Virgil C. Summer Nuclear Station (VCSNS) Units 2 and 3
Combined License Nos. NPF-93 and NPF-94
Docket Nos. 52-027 & 52-028

Subject: VCSNS Units 2 & 3 LAR 14-14 R2: Revision 2 to Request for License Amendment: Structural Design of Auxiliary Building Floors

Enclosure 5

Structural Design of Auxiliary Building Floors

UFSAR Figure 3H.5-8, Auxiliary Building Operations Work Area (Tagging Room) Ceiling – Revise the information for Floor El. 133'-11" (Precast Concrete) as shown below.

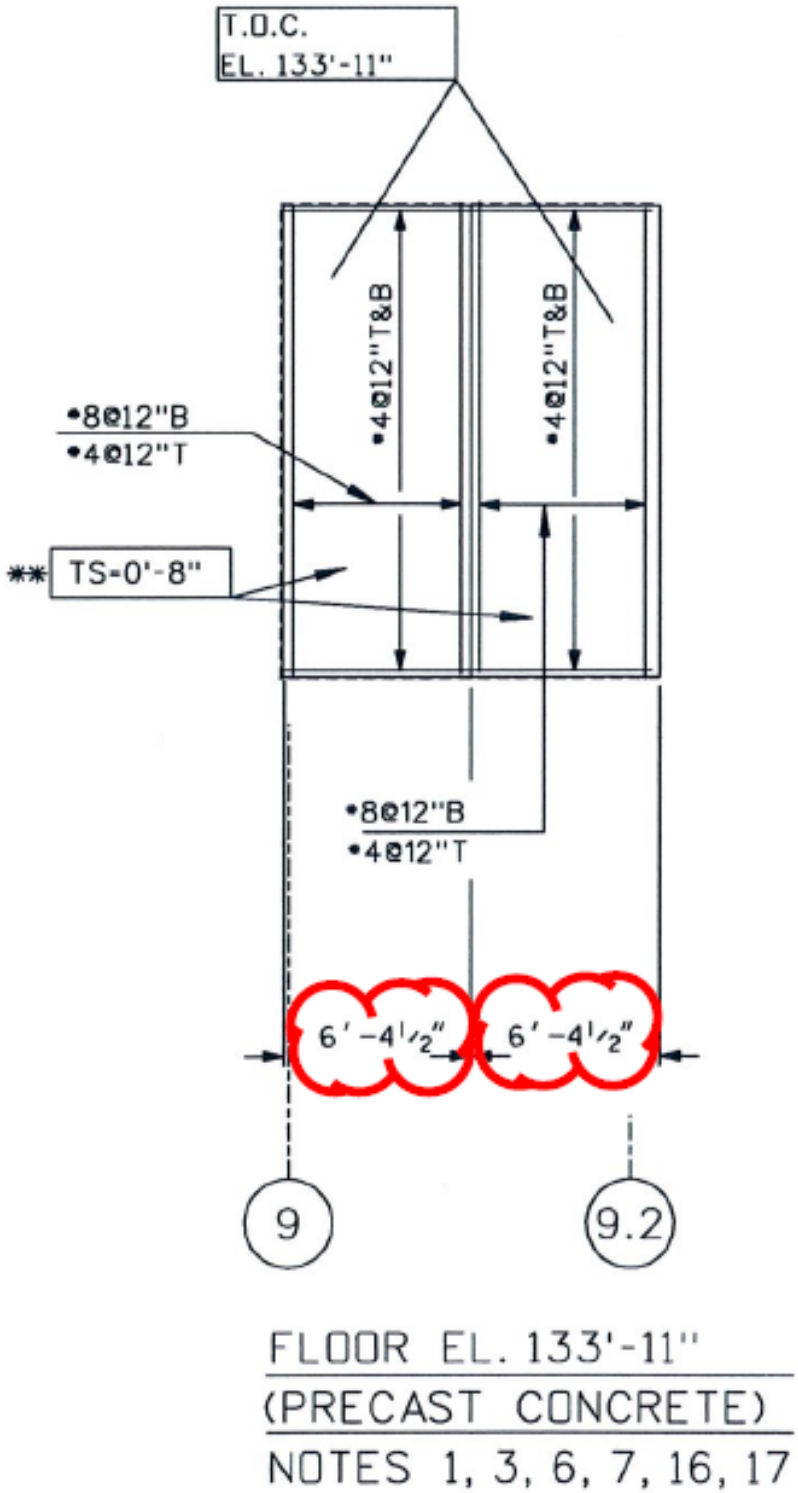
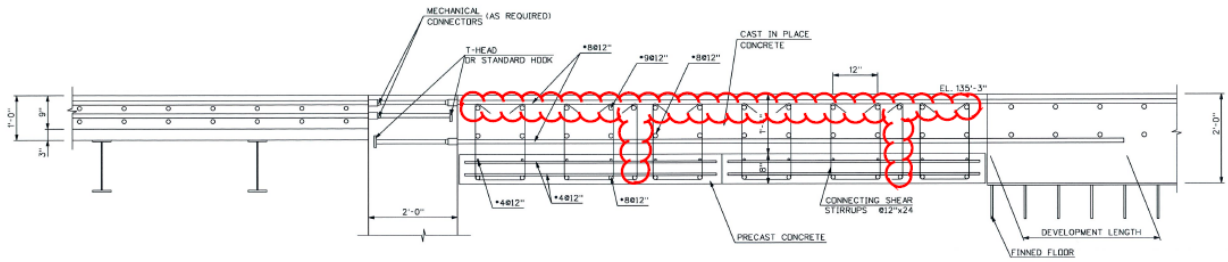
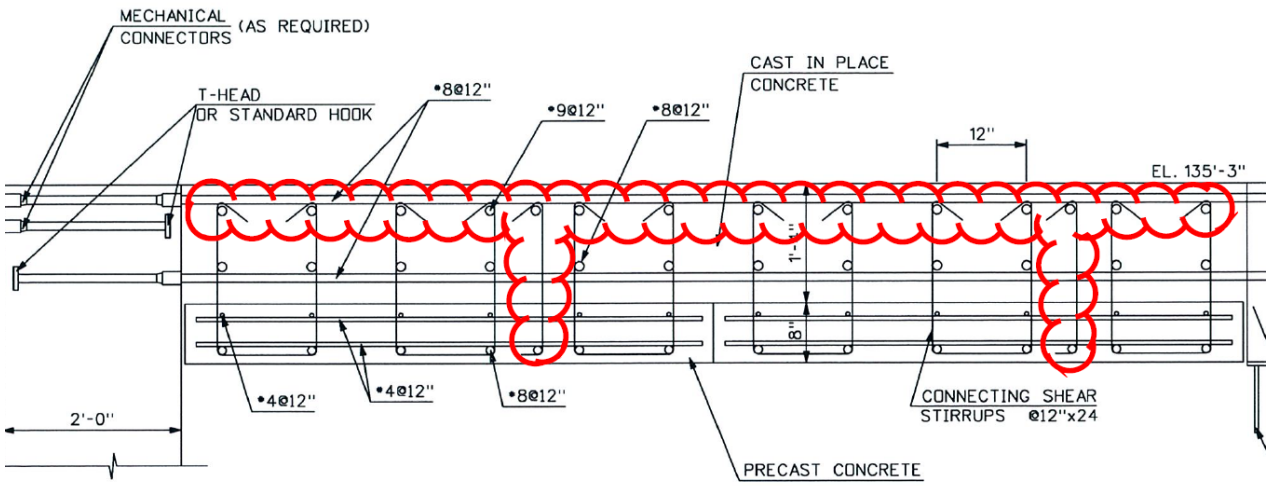
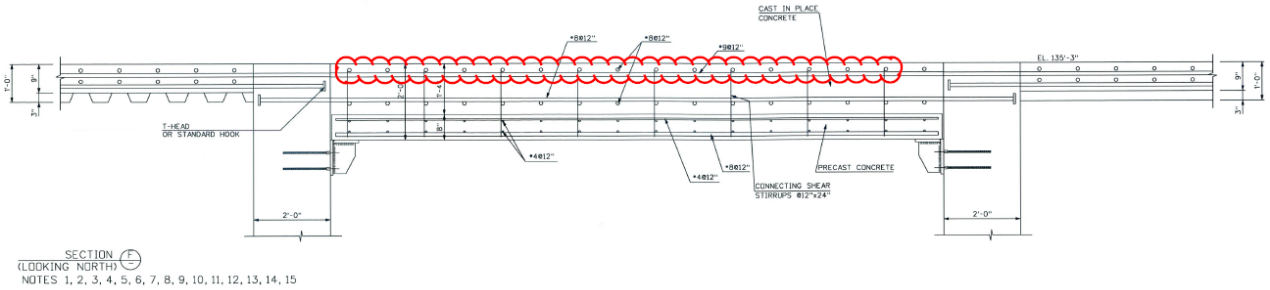
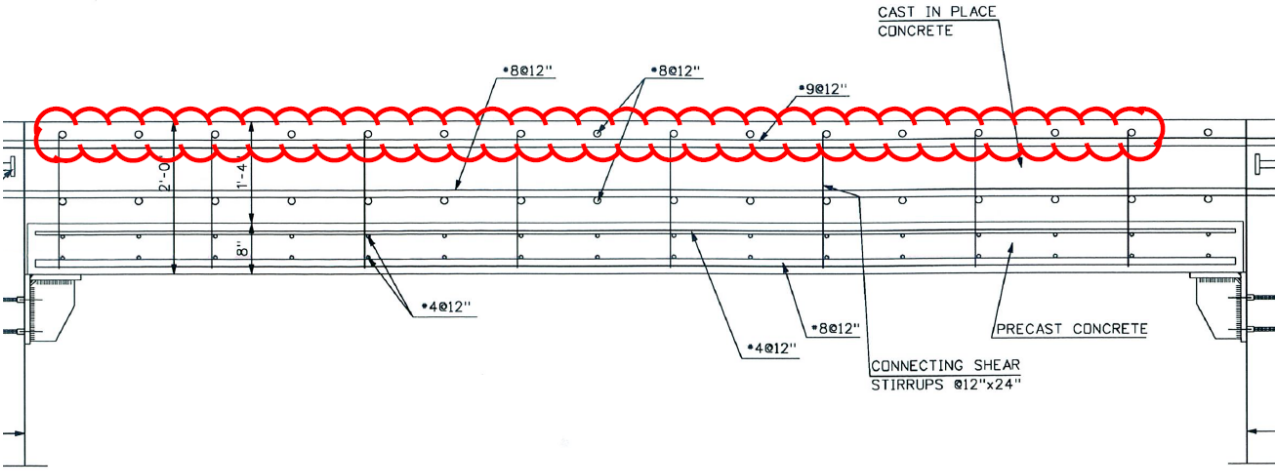
UFSAR Subsection 3H.5.3.1 describes, and UFSAR Figure 3H.5-8 shows, the design of the critical section for reinforced concrete floors constructed of cast-in-place concrete over precast panels. In this subsection and figure, the width of the precast concrete panels is stated and shown as 5′ 11″ in the text and in the view titled “Floor El. 133′-11″ (Precast Concrete)”. The proposed design change for this section proposes to change the width of the panels to 6′-4 ½″. The change in the width of the panels is because the 5′ 11″ panel width is not sufficient to fully cover the room below. The dimensions of the room are not changing. The figure shows three double stirrups connecting the precast panel to the cast-in-place concrete. The proposed design change for this section proposes to add a single stirrup for the wider panel to meet ACI 349, Chapter 17 requirements and the orientation of the hooks on the top of the stirrup being in the plane of the stirrup to facilitate fabrication.

Changes are proposed to the size of the precast concrete panels for the reinforced concrete floor shown in UFSAR Figure 3H.5-8 to optimize the construction of the floor. The increase in width also requires an additional row of stirrups to meet ACI 349 Chapter 17 requirements for the precast panel and cast in place concrete to act as a composite section. The orientation of the hooks on the stirrups is changed to facilitate construction. The design with the proposed changes shown in the revised UFSAR Figure 3H.5-8 is in conformance with design and analysis requirements for the structures identified in the UFSAR including ACI 349.

Revise UFSAR Subsection 3H.5.3.1 and UFSAR Figure 3H.5-8 to show the width of the precast panels to be 6′-4 ½″. Revise UFSAR Figure 3H.5-8, Section C, to show three double stirrups and one single stirrup connecting the precast panel and cast-in-place concrete. Revise UFSAR Figure 3H.5-8, Sections C and F, to reorient the hooks on the stirrups to be in the plane of the double stirrup.

I. Revise UFSAR Figure 3H.5-8 as follows: (Change Activity 9)

1. In the view labeled Floor EL. 133′-11″ (Precast Concrete) change the panel width from 5′-11″ to 6′-4½″.
2. In Section C add a row of single stirrups to each of the two precast panels.
3. In Section C and F reorient the hooks on the stirrups to be in the plane of the double stirrup.

UFSAR Figure 3H.5-9 (Sheet 1 of 3), Auxiliary Building Finned Floor – Revise the information as shown below.

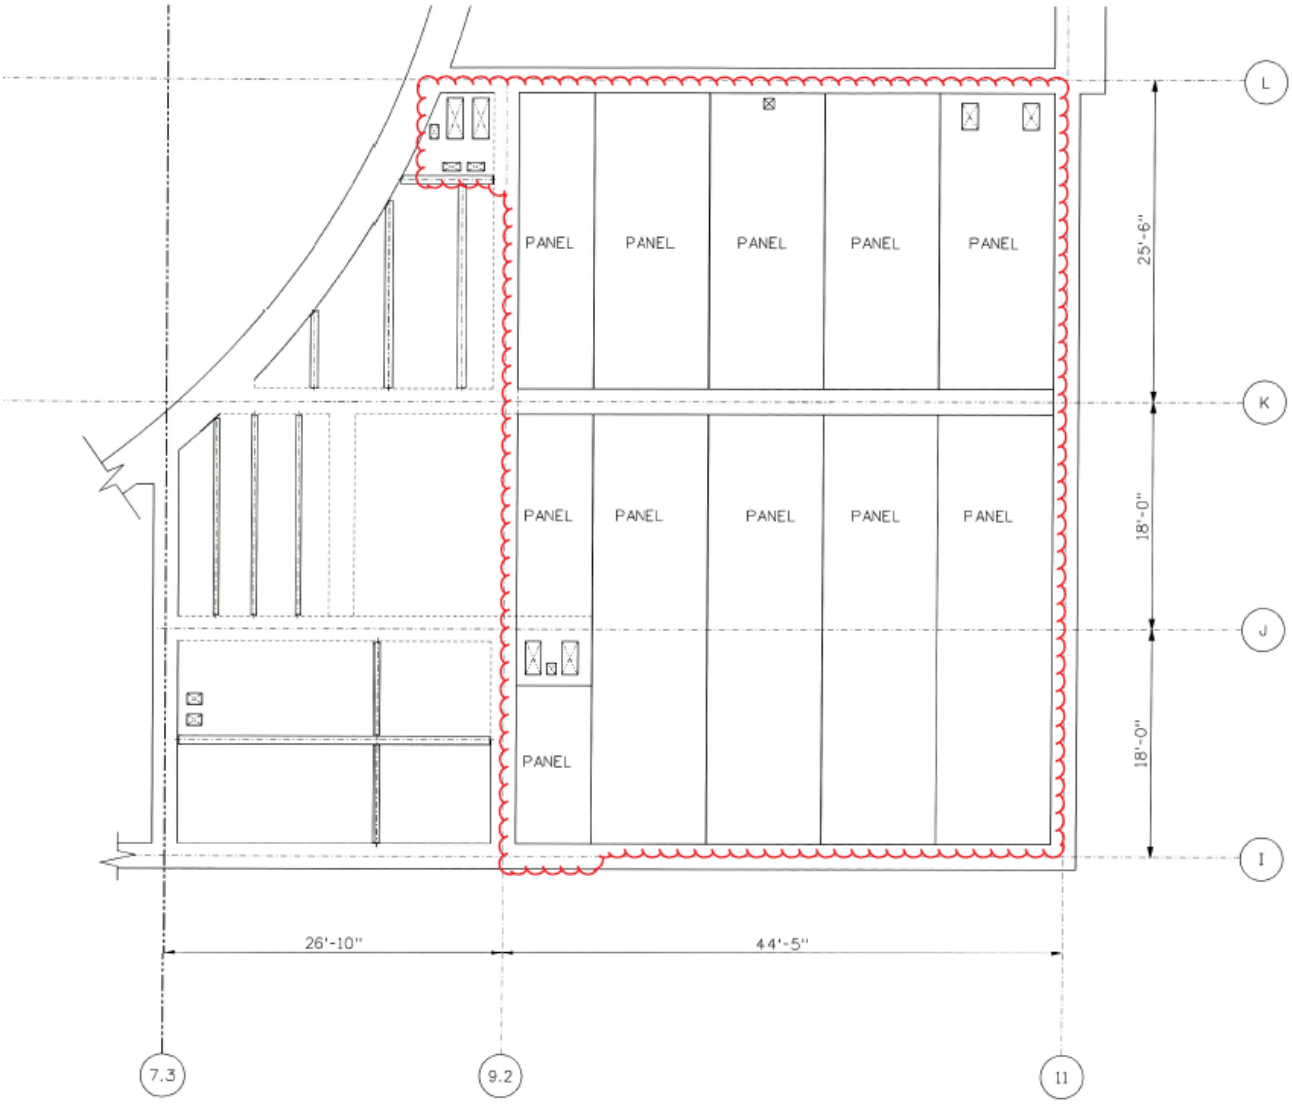
UFSAR Figure 3H.5-9, Sheet 1, shows four finned floor steel plates (panels) between column lines 9.2 and 11 from column lines I to L. It is proposed that the number of plates between column lines 9.2 and 11 be increased to facilitate fabrication and construction.

Openings for HVAC ducts in the ceiling of the main control room are shown in the finned floor critical section UFSAR Figure 3H.5-9, Sheet 1. A proposed change relocates these openings on the figure because of rerouting of the HVAC ducts. The openings are moved out of the floor

above the main control room to the floor above another room within the control room envelope. In addition, openings shown on the left side of the figure adjacent to column line 9.2 are reconfigured because of final design changes in routing.

J. Revise UFSAR Figure 3H.5-9, Sheet 1, as follows: (Change Activities 1, 3, and 4)

1. Revise the figure to show six finned floor steel panels between column lines 9.2 and 11 from column lines I through K, and show five finned floor steel panels between column lines 9.2 and 11 from K through L.
2. Revise the figure to move the rectangular openings for HVAC ducts from along column line 11 near column lines I and J to along column line L near column line 11.
3. Add notes to the figure to provide the following information
   a. State that the section shown is a specific location and other locations will have variations in design details.
   b. State that the number of steel panels in the floor varies.
   c. State that the openings for piping, HVAC ducts, or cable trays may vary.

1. DETAIL SHOWN IS SPECIFIC TO THE REINFORCED CONCRETE FLOOR AT EL. 135'-3" (MAIN CONTROL ROOM CEILING). REFER TO THIS AND OTHER NOTES FOR ADDITIONAL INFORMATION ABOUT DESIGN DETAILS FOR OTHER FLOOR SECTIONS AND FOR CONNECTIONS TO OTHER WALLS.

3. THE OPENINGS FOR PIPING, HVAC DUCTS, OR CABLE TRAYS MAY VARY.

UFSAR Figure 3H.5-9 (Sheet 2 of 3), Auxiliary Building Finned Floor – Revise the information to add the Notes shown below.

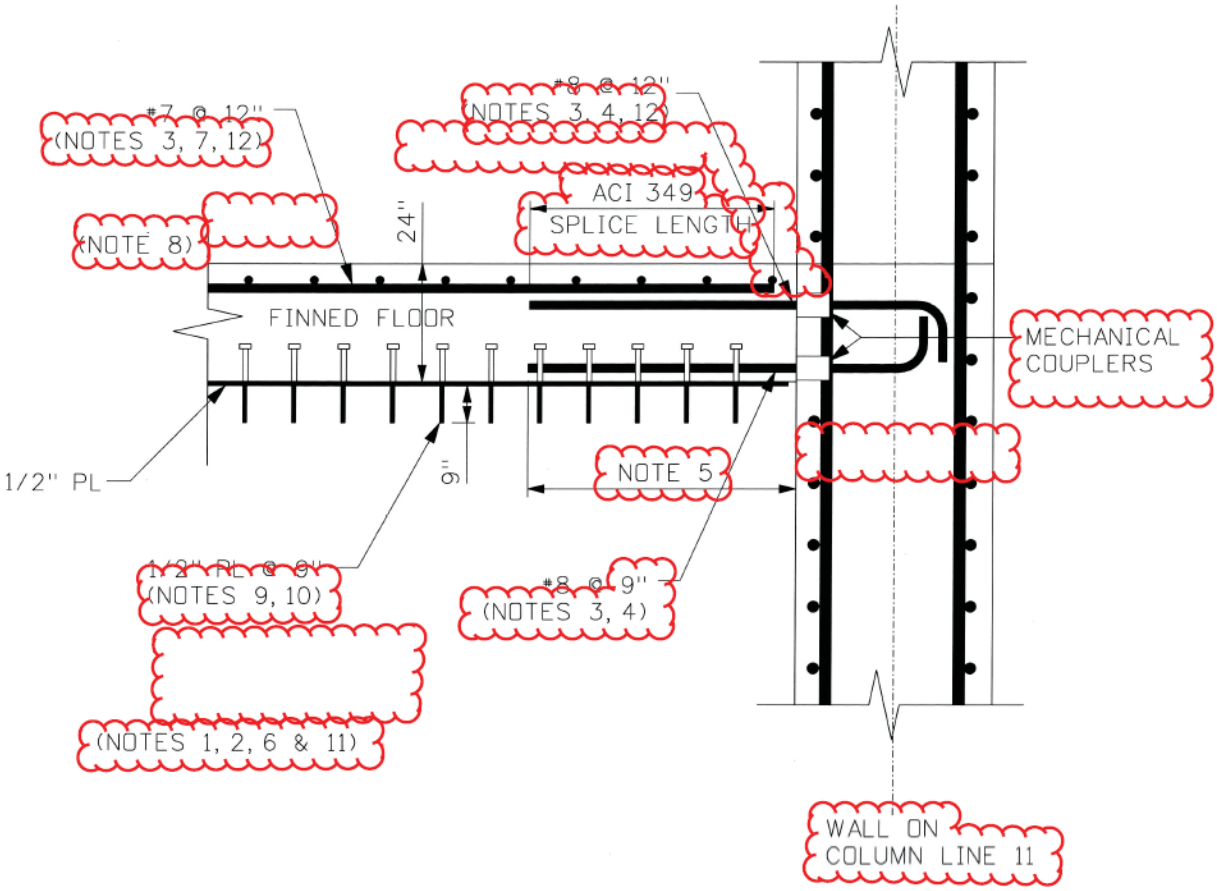
Proposed design changes are identified to the detail reinforcement design of the finned floor to wall connection represented in UFSAR Figure 3H.5-9, Sheet 2. The figure shows a floor to wall connection including reinforcement dowels connected to the wall and studs attached to the steel plate on the bottom of the floor. The figure identifies a length for the dowel for the critical section. The dowel length used for the critical section is not used at all locations. UFSAR Figure 3H.5-9 includes detail fabrication design and construction sequence information that is not needed or appropriate in licensing basis figures. The figure also includes incidental location information that is unnecessary or confusing and should be removed or corrected.

The length for the reinforcement bar dowel is removed to allow for different lengths for the reinforcement bar dowels in UFSAR Figure 3H.5-9, Sheet 2, because the ACI code requires different lengths based on the reinforcement size used for other sections. Also, the length of the bottom dowels must be sufficient to incorporate sufficient shear studs to develop the capacity of the dowels and the demand in the bottom plate. The design of the connection meets the

K. Revise UFSAR Figure 3H.5-9, Sheet 2, as follows: (Change Activities 1, 2, 5, and 8)

1. Revise spacing of the bottom reinforcement bar dowel to @9″.
2. Remove reference to construction joint.
3. Remove designation of 135′-3″ elevation; replace with Note 8.

4. Remove size of the bottom dowel length; replace with Note 5.
5. Remove size of the top dowel length, replace with “ACI 349 SPLICE LENGTH”. Move the top reinforcement dimension line from the face of the wall to the end of the top reinforcement.

6. Remove information on gap between steel plate and wall.
7. Replace the term “Mechanical Splices” with “Mechanical Couplers”.
8. Remove North–South designator.

9. Revise wall designation to say “WALL ON COLUMN LINE 11”.
10. Add notes to the figure to provide the following information:
    a. State that the section shown is a specific location and other locations will have variations in design details. (Note 1)

c. State that the reinforcement and connecting dowels shown are for locations away from obstructions. (Note 3)
d. Identify the code requirements for reinforcement spacing and size, and provide the range of reinforcement spacing and size. (Note 4)

1. DETAIL SHOWN IS SPECIFIC TO THE REINFORCED CONCRETE FLOOR AT EL. 135'-3" (MAIN CONTROL ROOM CEILING). REFER TO THIS AND OTHER NOTES FOR ADDITIONAL INFORMATION ABOUT DESIGN DETAILS FOR OTHER FLOOR SECTIONS AND FOR CONNECTION TO OTHER WALLS.

12. THE NUMBER OF LAYERS OF TOP REINFORCEMENT AND TOP DOWELS ALONG EACH DIRECTION MAY VARY AS LONG AS THE MINIMUM REQUIRED REINFORCEMENT IS PROVIDED PER ACI 349.
